Jaroms Industries Ltd. (11719)

06.AUGUST.2014

Identified Priority 1 Concerns

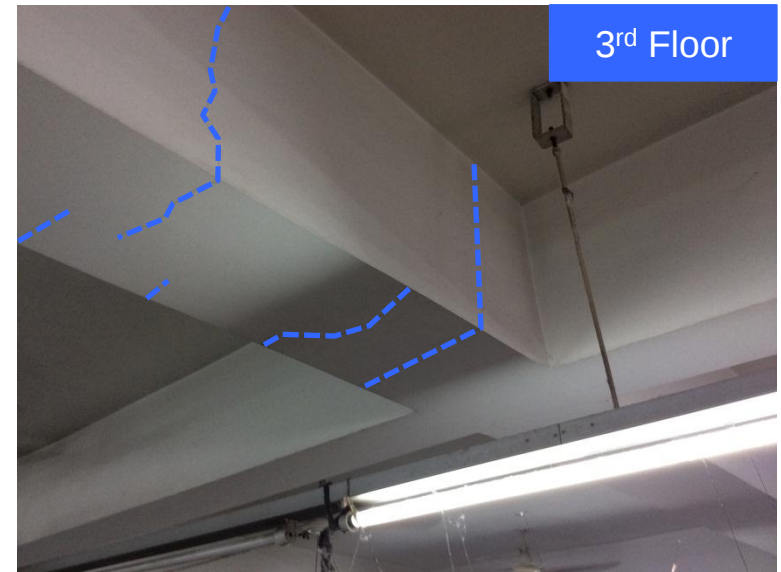
- If the full construction of 10 storeys takes place, the internal columns at basement level will be overstressed.

If the full construction of the 10 storeys is completed, the internal columns at basement level shown below will be overstressed. The size of these column is 600 x 600 mm at basement level and will carry a full 10 storeys of building with spans of 9.14 m and 8.23 m.

From the information above, for full construction, 10 storeys, the calculation check of these columns show that they will be overstressed (FoS = **1.18**).

Item No.	Observation	Recommended Action Plan	Recommended Timeline
1	Priority 1 - If the full construction of 10 storeys takes place, the internal columns at basement level will be overstressed.	Factory Engineer to review design, loads and columns stresses in area identified above. Verify in-situ concrete stresses either by cores or existing cylinder strength data for [the identified columns / cores from 4 columns]. A Detailed Engineering Assessment of Factory to be commenced immediately.	Immediate - Now
2	Priority 1 - If the full construction of 10 storeys takes place, the internal columns at basement level will be overstressed.	Produce and actively manage a loading plan for all floor plates within the factory giving consideration to floor capacity and column capacity. The Detailed Engineering Assessment to be completed and any recommended actions completed.	6-weeks
3	Priority 1 - If the full construction of 10 storeys takes place, the internal columns at basement level will be overstressed.	Maintain and continue to implement floor load plans. If the main DEA recommendation is not to complete the full 10 storeys then this is to be followed.	6-months

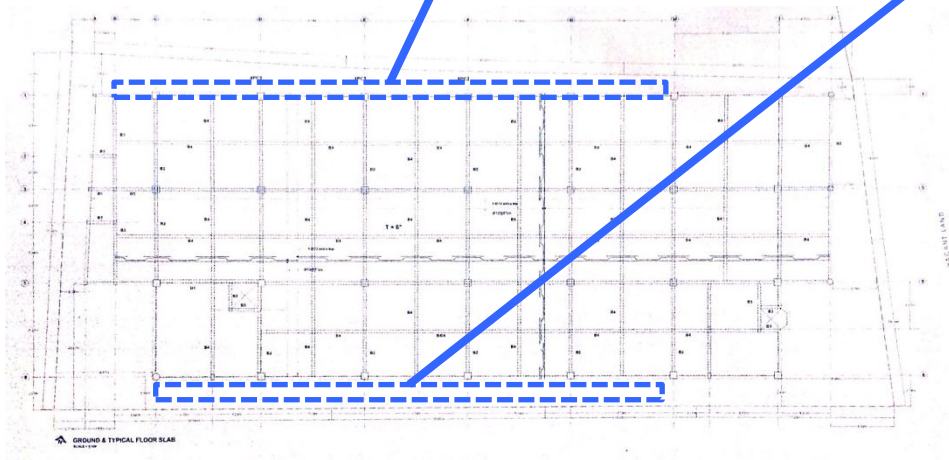
Cracks on ground floor, 1st floor, 2nd floor and 3rd floor beams and slab soffits. The cause of cracks should be investigated as part of a DEA, a Detailed Engineering Assessment.

There are cantilevered slabs on 1st floor, 2nd floor and 3rd floor in areas as shown above. However, these cantilevers are not shown on the structural drawings. We recommend a survey of the actual conditions and revise the as-built drawings.

4	Priority 2 - Cracks on ground floor, 1st floor, 2nd floor and 3rd floor beams and slab soffits.	Investigate the cause of cracks as part of a Detailed Engineering Assessment. The distress found is to be suitably rectified and then repaired.	6-weeks
5	Priority 2 - Cracks on ground floor, 1st floor, 2nd floor and 3rd floor beams and slab soffits.	Create loading plans for each floor level. Maintain standards of quality control to ensure that loading plan is correctly followed so that problems do not arise in the future. Maintain and enforce the loading plans.	6-months

Item No.	Observation	Recommended Action Plan	Recommended Timeline
6	Priority 2 - Inadequacies between the drawings and the actual as-built conditions.	Factory Engineer to survey the actual conditions and revise the drawings. Any results of the Detailed Engineering Assessment which affect the structure should be taken on board.	6-weeks
7	Priority 2 - Inadequacies between the drawings and the actual as-built conditions.	Continue to implement load plan.	6-months
8	Priority 2 - Capacity check of 3rd floor slab supporting water tanks.	Factory Engineer to review design, loads and related elements in area identified above to confirm capacity for this item.	6-weeks
9	Priority 3 - Reinforcement left exposed at top level.	Clean rebar before further construction. For both durability and serviceability, rust proof paint or any appropriate methods is recommended.	6-months
10	Priority 3 - Distress due to water ingress.	Factory Engineer to inspect water damaged structures and repair with a suitable methods. Waterproofing on the roof slab is to be applied. Moreover the roof slab drainage system should be investigated and improved.	6-months
